**To:** Design Review Board  
**From:** Tony Leavitt, Associate Planner  
**Date:** January 7, 2013  
**File No.:** DRV12-01513  
**Subject:** 324 CENTRAL WAY MIXED USE PROJECT  
CONCEPTUAL DESIGN CONFERENCE

# Conceptual Design Conference Analytic Design Proposal Packet

IMPROVEMENT SECTION & LETTER  
 CONCEPTUAL DESIGN CONFERENCE- 324 CENTRAL WAY

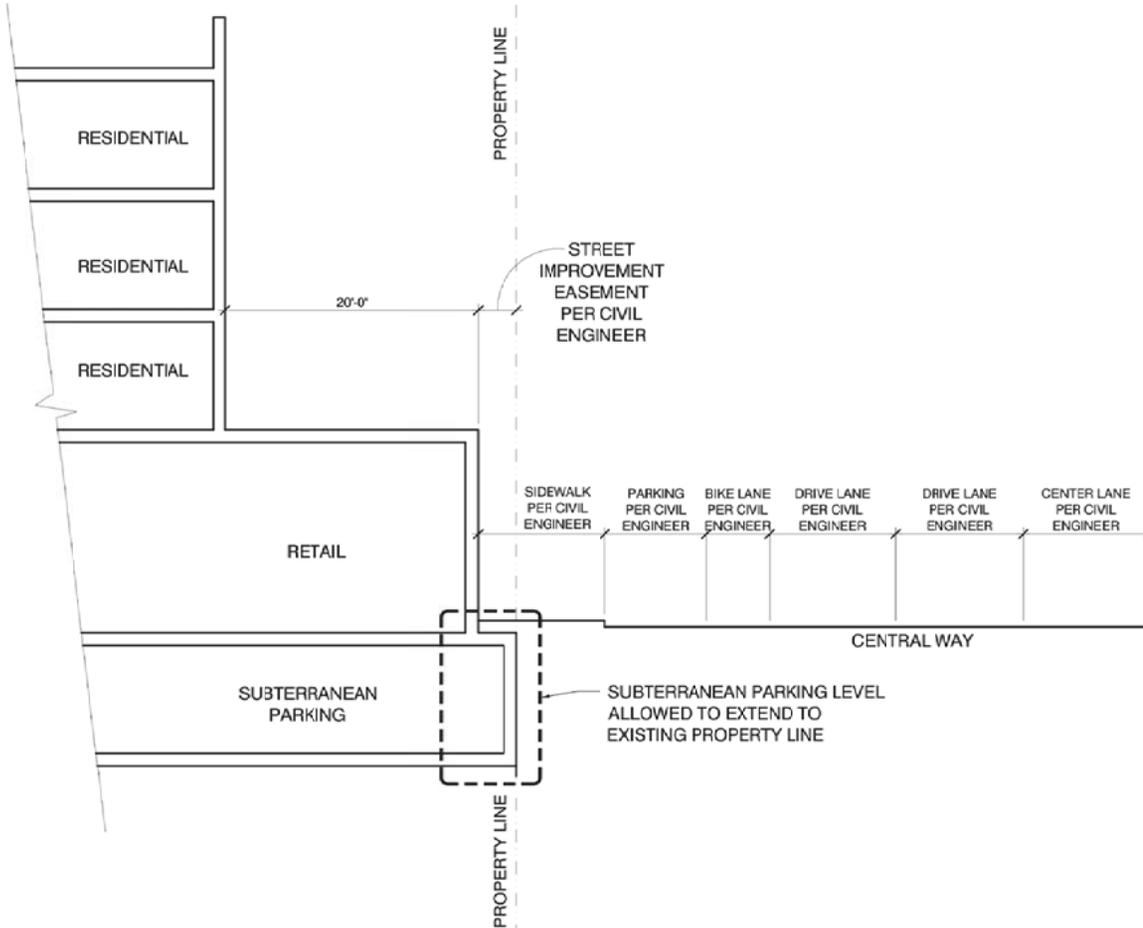
This letter follows up on your questions regarding the required frontage improvements for redevelopment of the White Swan Carwash property in Downtown Kirkland. Public Works has the following comments:

- The 3.68' dedication (width to be verified by the project Architect/Engineer and confirmed by the City) for the sidewalk/frontage improvements may be contained within an easement. An easement would allow a portion of the parking garage to be located under the sidewalk without extending into the right-of-way.
- The on-street parking stall width can be reduced to 7.5 feet.
- The bike lane needs to be 5 feet in width.
- The 10-foot sidewalk width may include the 0.5 feet curb.

In regards to setbacks, the Zoning Code required front yard setback should be measured from the sidewalk/frontage improvement easement described above. The final setback and building configuration will be determined through the design review process since the Design Review Board has the authority to approve departures from the minimum setback requirements in the CBD.
